December 21, 2011

**RE: Docket # 11-IEP-1A- Lead Commissioner's Draft Report – 2011 Integrated Energy Policy Report (IEPR)**

Table 1  
CEC demand forecast for SoCalGas vs. 2010 CGR demand forecast for SoCalGas

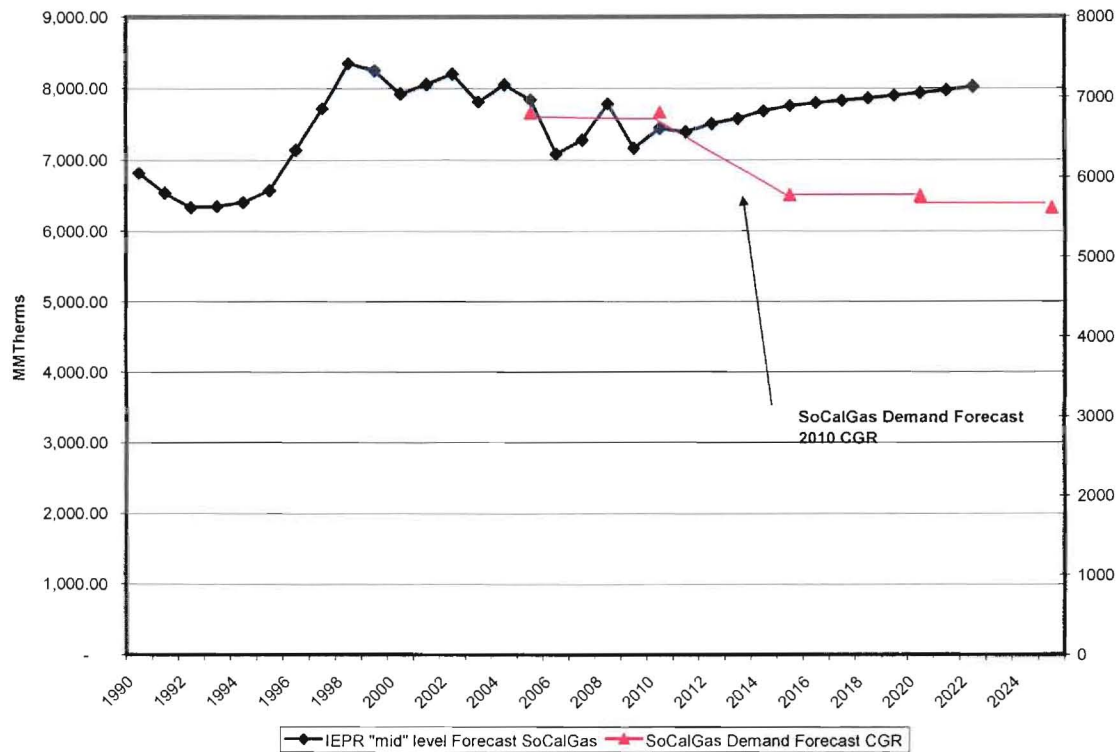
The CEC forecasts are significantly higher than the forecasts the California utilities prepared for the *2010 California Gas Report (CGR)*. The disparity between the forecasts is only 9% different in 2010 but the gap widens to 38% by the year 2020. The reason for this is likely due to more optimistic economic and customer growth forecasts and the fact that the CGR incorporates out-of-model adjustments which include energy efficiency savings and the expected savings attributable to AMI. SoCalGas and SDG&E assume that energy efficiency programs will continue beyond the current three-year Energy Efficiency program cycle while the CEC assumes no savings beyond the currently approved energy efficiency program funding. We recommend that the CEC revise its forecast and recognize energy efficiency savings beyond the current program years.

CEC Demand Forecast for SDG&amp;E vs. 2010 CGR Average Year Demand Forecast for SDG&amp;E

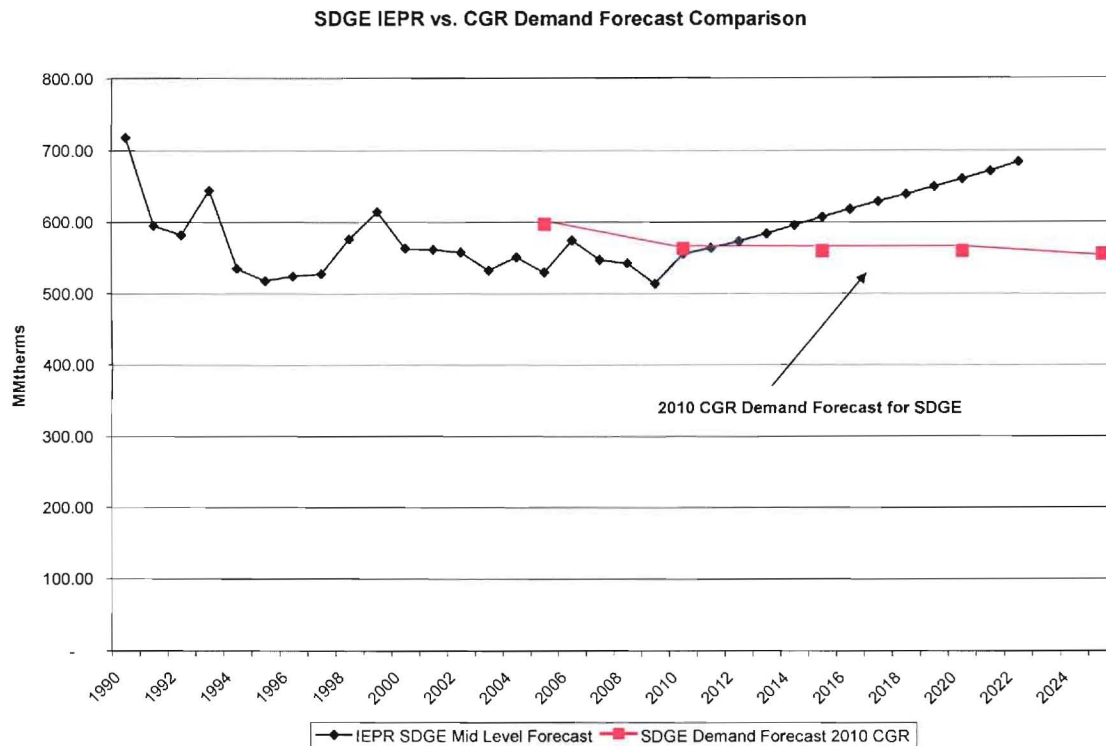
The disparity between the CEC's forecast and the CGR forecast is only about 1% different in 2010. The disparity widens to 18% by the year 2020. The reason for the widening disparity is likely caused by the fact that SDG&E incorporates various out-of-model adjustments which include state-mandated, energy efficiency savings as well as the conservation anticipated due to advanced meters.
